REVISED STAFF REPORT: JUNE 11, 2025 MEETING

APPLICATION NUMBER: HDC2025-00262

ADDRESS: 15064 MINOCK STREET

SCOPE: REPLACE VINYL AND WOOD WINDOWS WITH VINYL WINDOWS

Rear 1971 addition photos submitted by applicant.

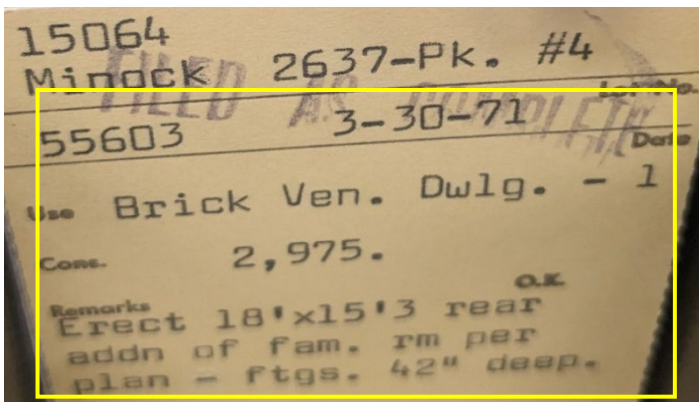
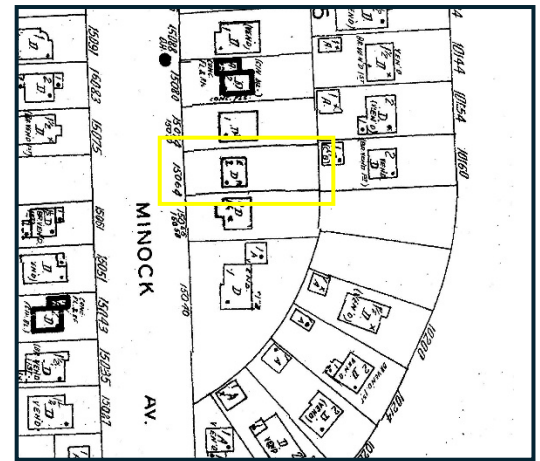
- Per the Sanborn Map, (shown here) the rear addition was not part of the original house.
- The rear addition to the home was added to the home in 1971, outside of the period of significance. Therefore, any changes made to the windows of the rear addition only need to be compatible with the addition and are held to a lesser standard.

- Per the Elements of Design, wood is a prevalent material used for windows in the historic district.
- Per the above NPS guidelines, it is staff's opinion that the most appropriate/compatible window replacement treatment in the main house/historic portion is double-hung wood or aluminum clad wood windows that faithfully reproduce historic prototypes. ~~Consumer-grade~~ Vinyl windows are not compatible for historic replacements. However, on the 1970s non-historic addition, vinyl windows are compatible.

Recommendation 2 of 2 – COA – Install vinyl windows at non-historic rear addition
